CLASS II MODIFICATION 2019 - SUPPLEMENT
10/28/2019

Site Plan Supplement
Atlantic Crossing
Delray Beach
Florida

Drawing No.
SP-2B

Drawing No.
SP-3A

SITE PLAN

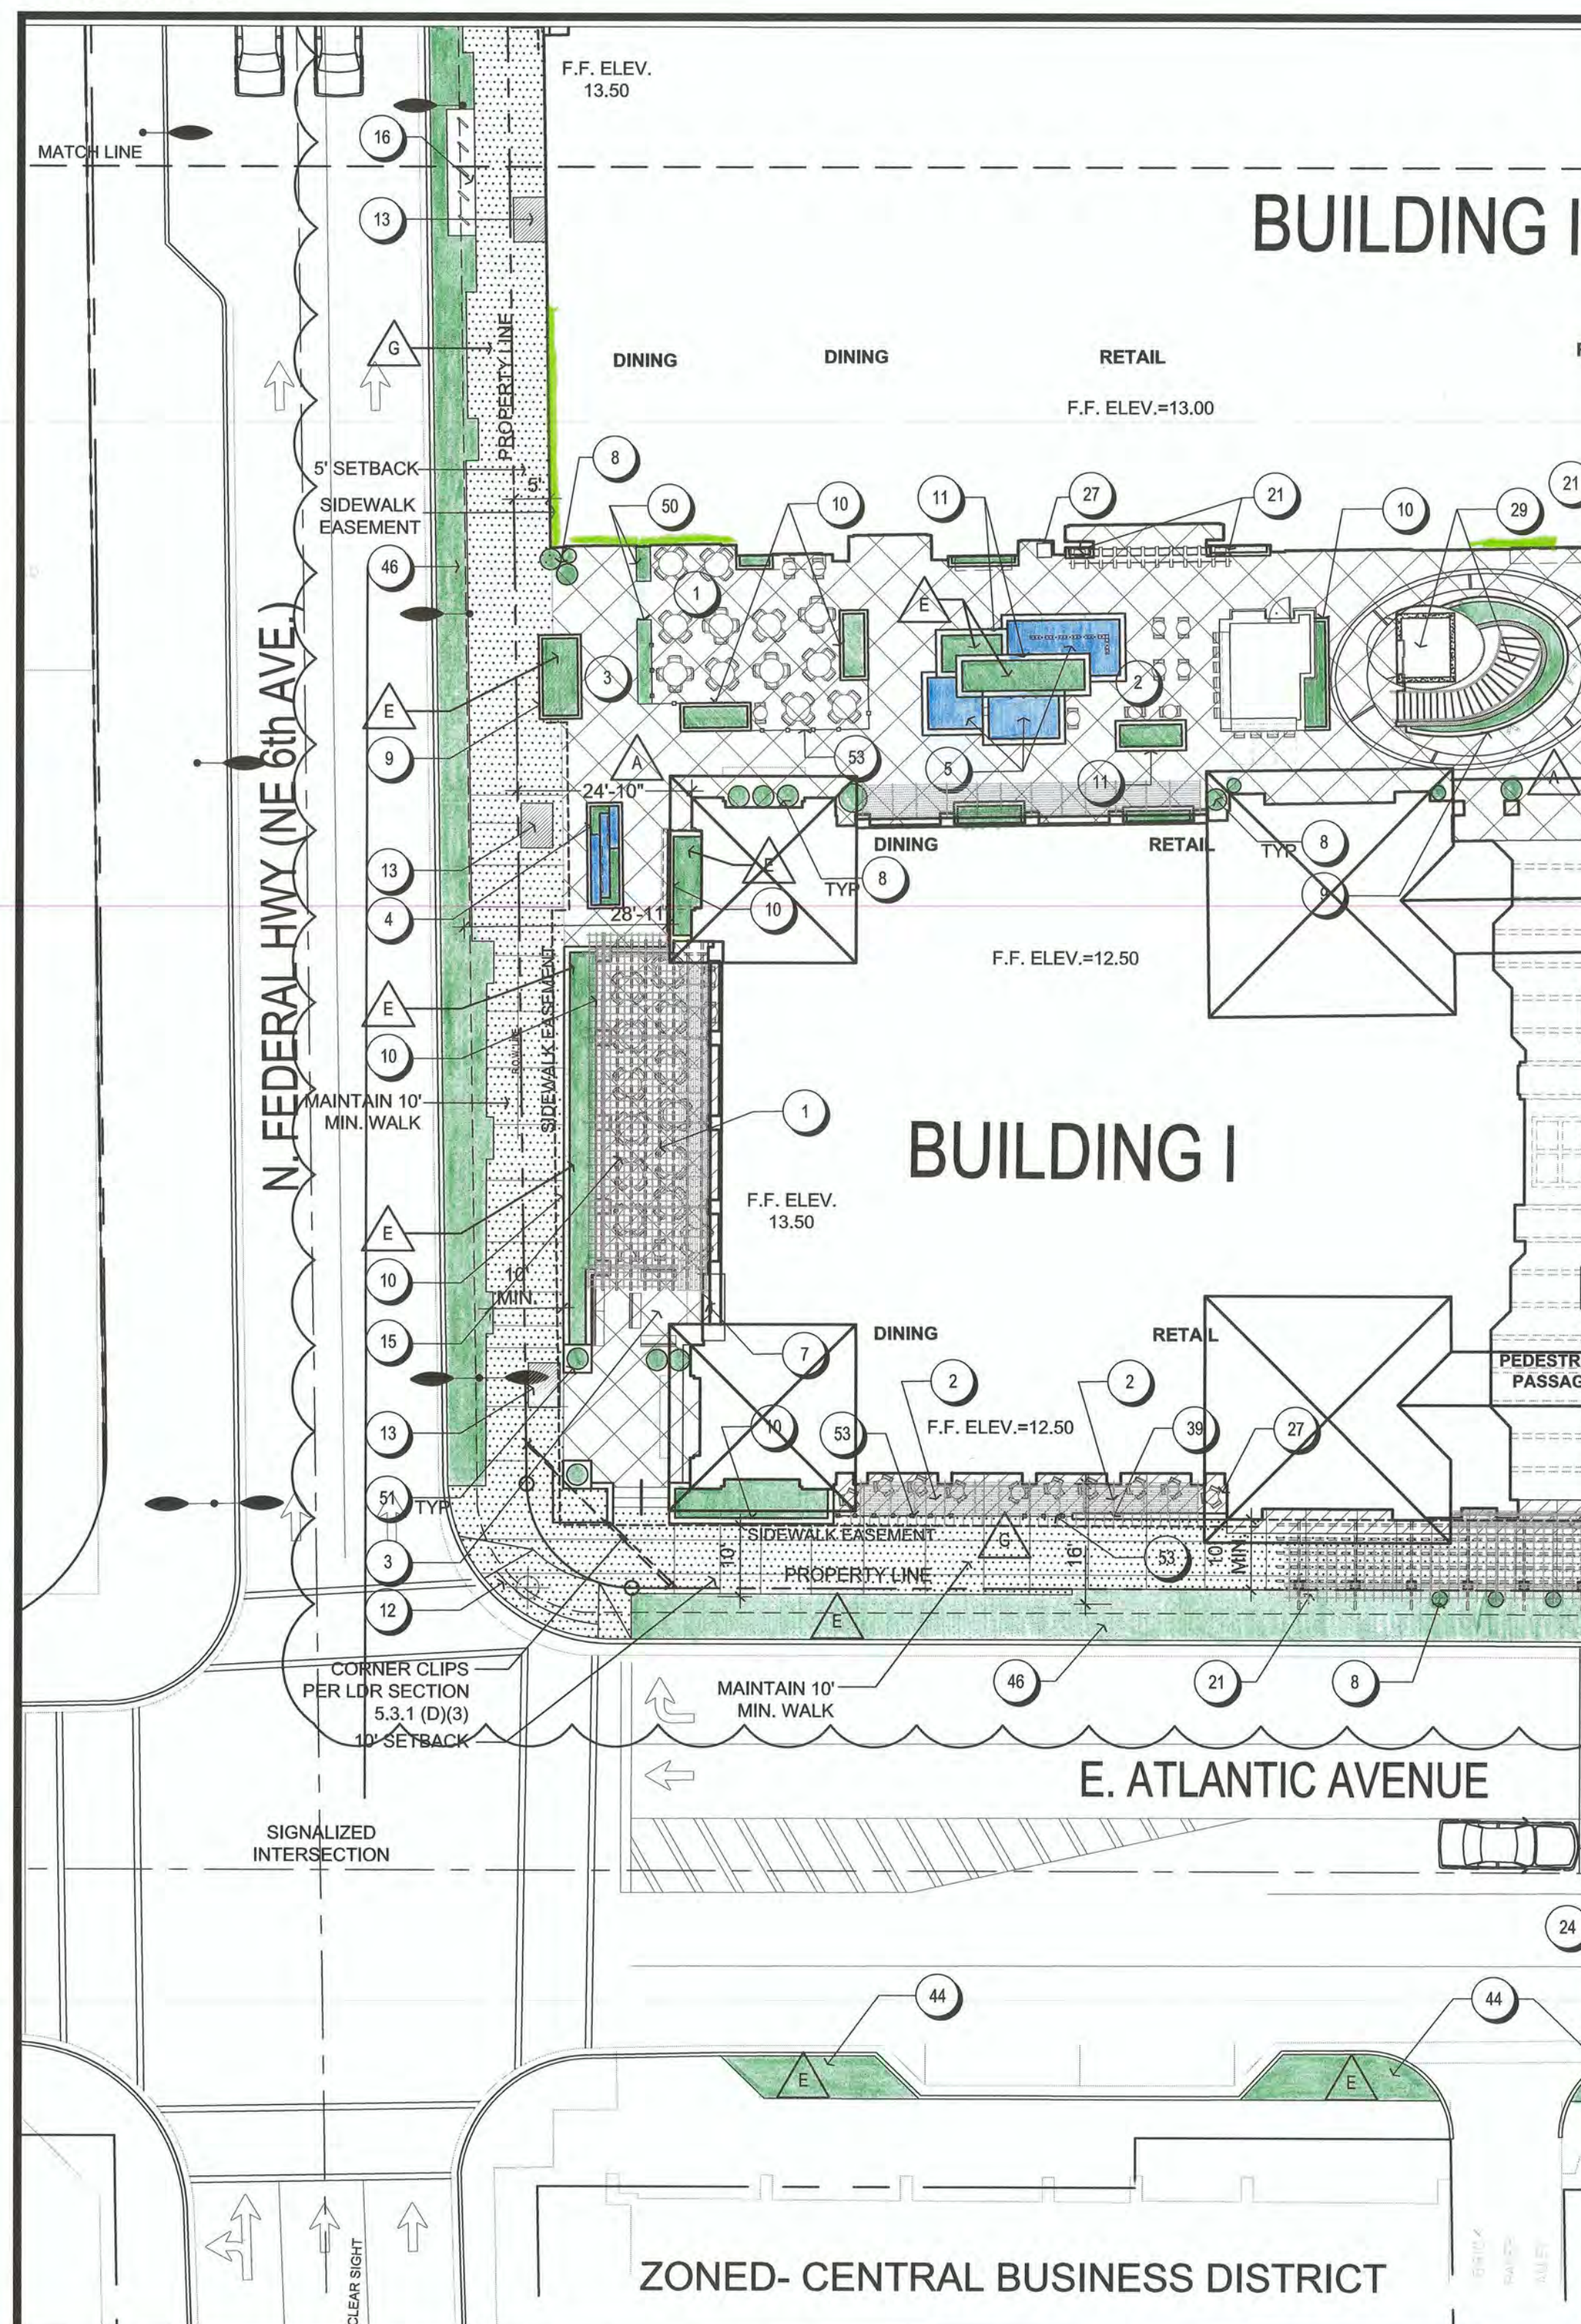
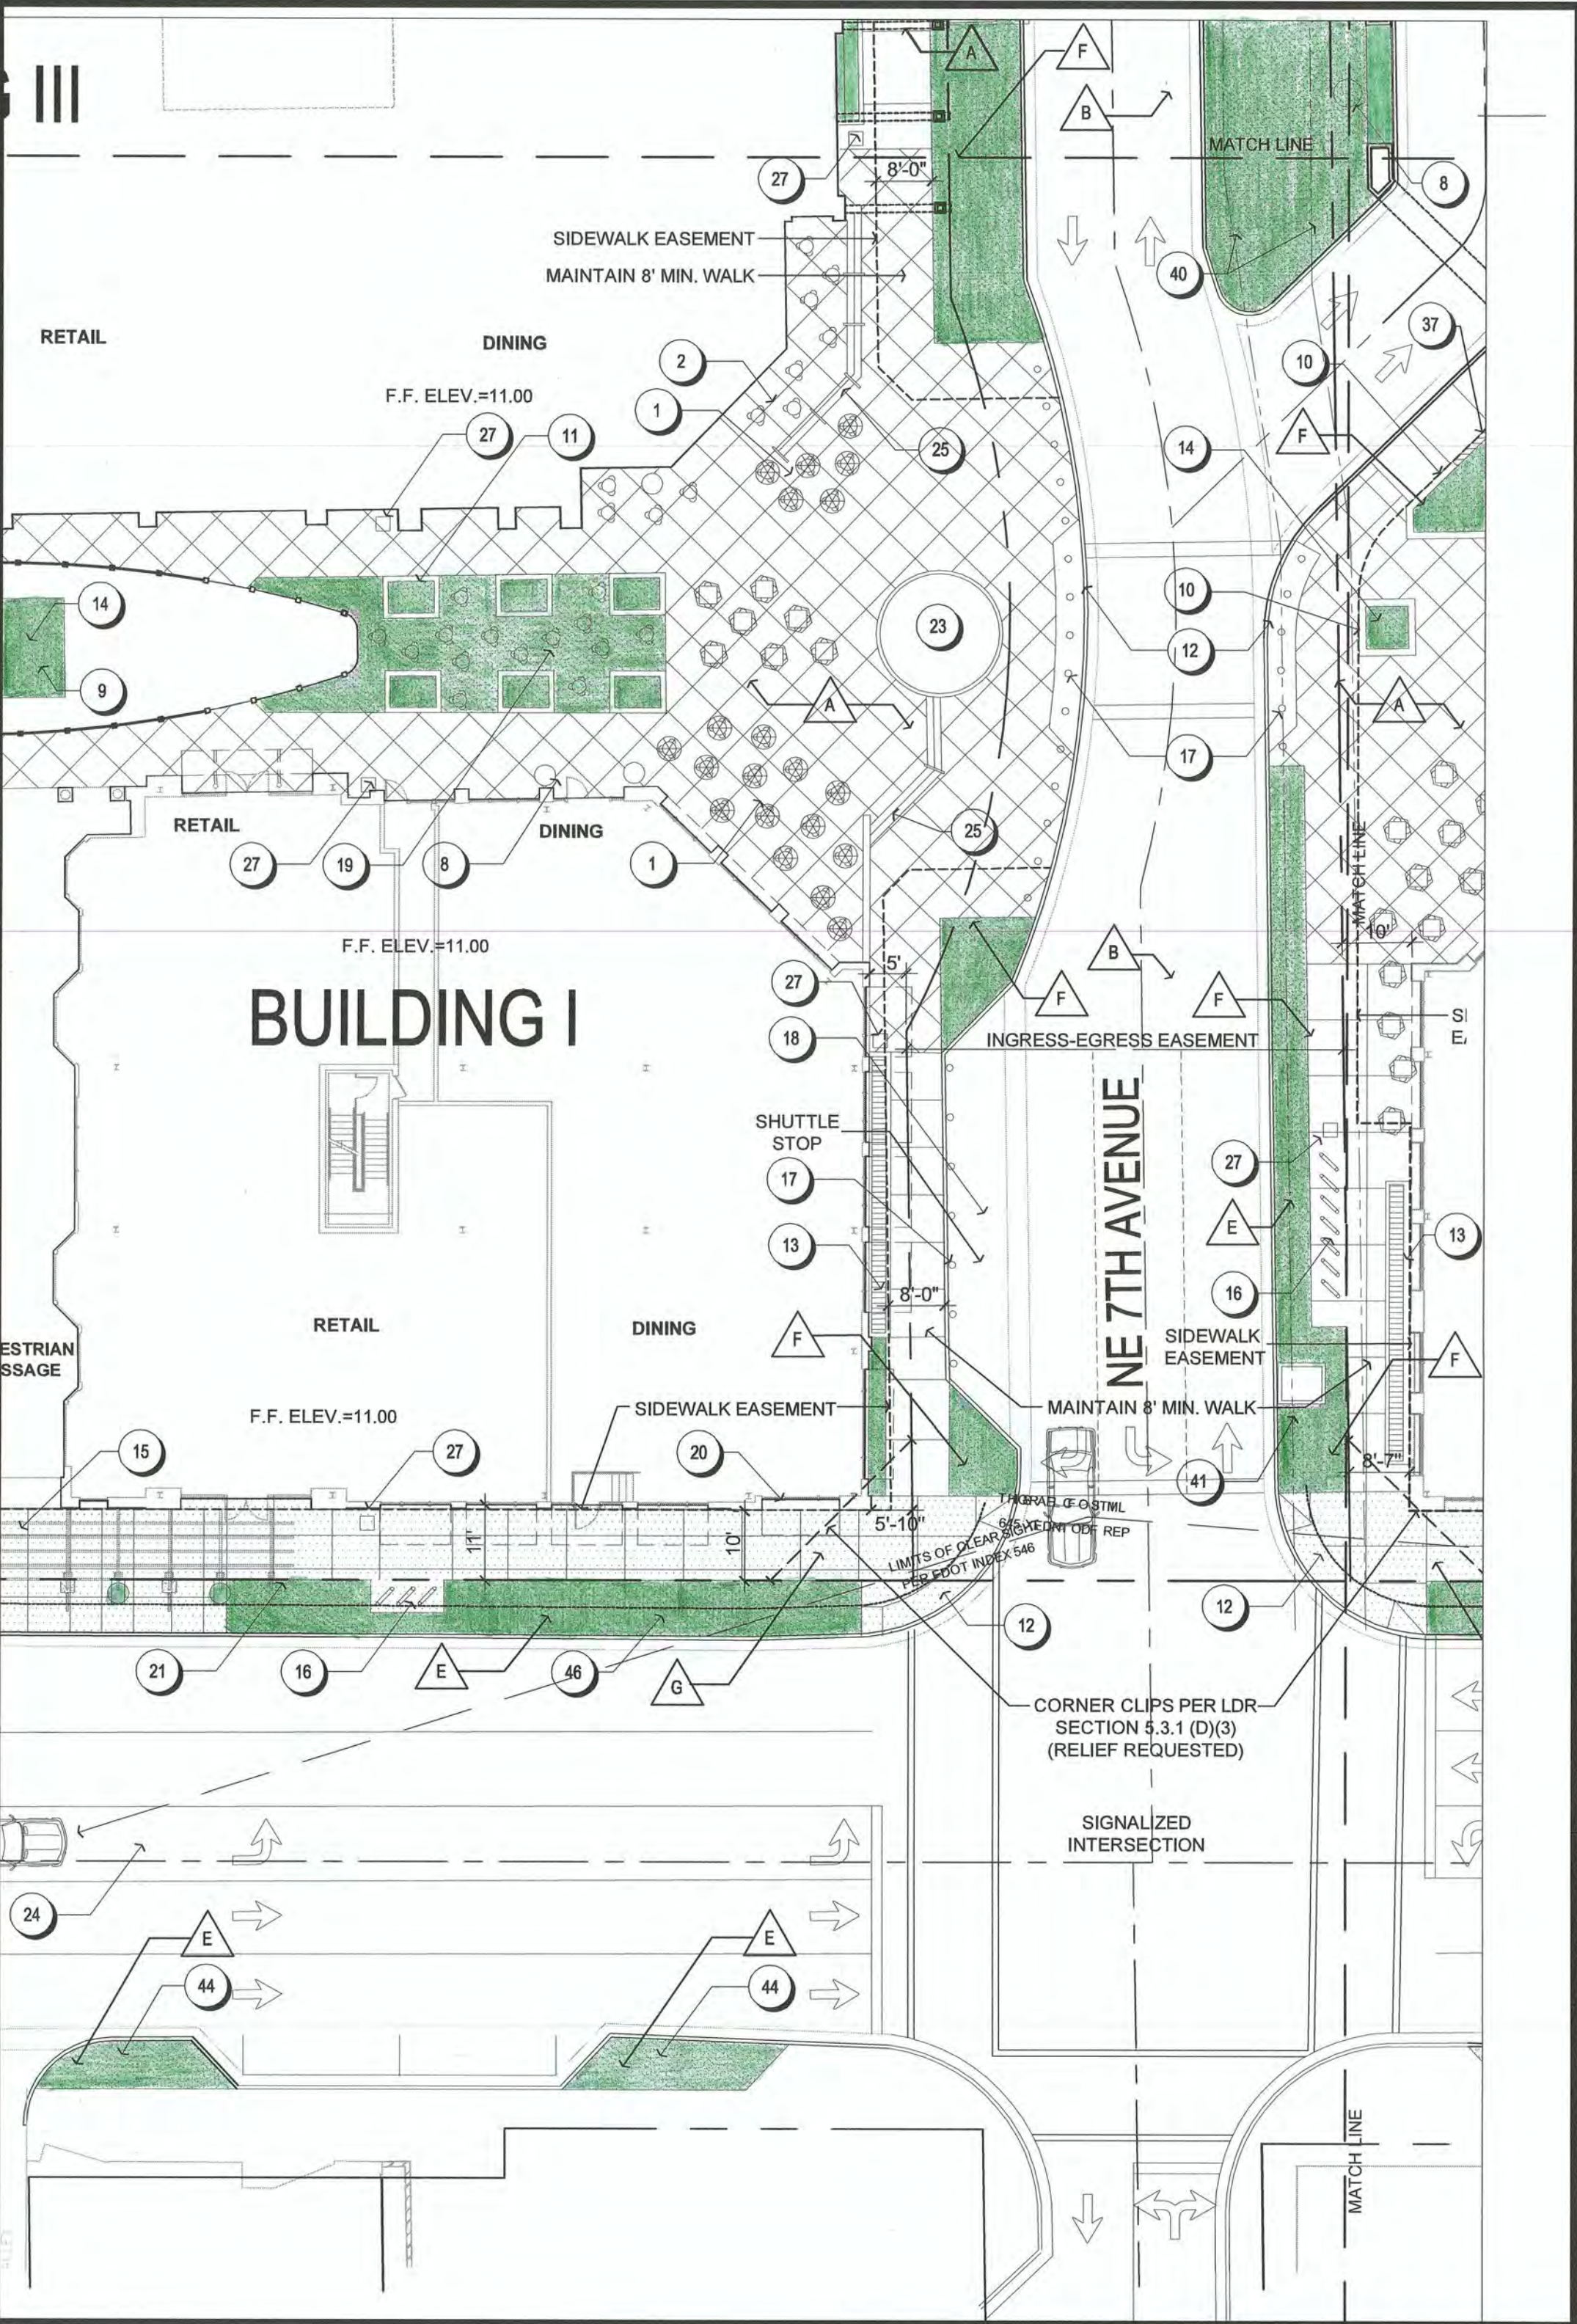
SUMMARY OF MODIFICATIONS

- 1. PLANTERS RE-DESIGNED TO ENABLE BETTER PEDESTRIAN FLOW TO ENABLE RETAIL TO SUCCEED.
- 2. AQUARIUM REPLACED BY ECHELMAN SCULPTURE.
- 3. RESTAURANT SEATING TERRACES BETTER DEFINED WITH PLANTER WALLS.
- 4. STAGE ADDED FOR SMALL MUSICAL PERFORMANCES.
- 5. INCREASED GREEN SPACE.
- 6. PLANTER BENCHES PROVIDE VIEWING FOR ECHELMAN SCULPTURE.
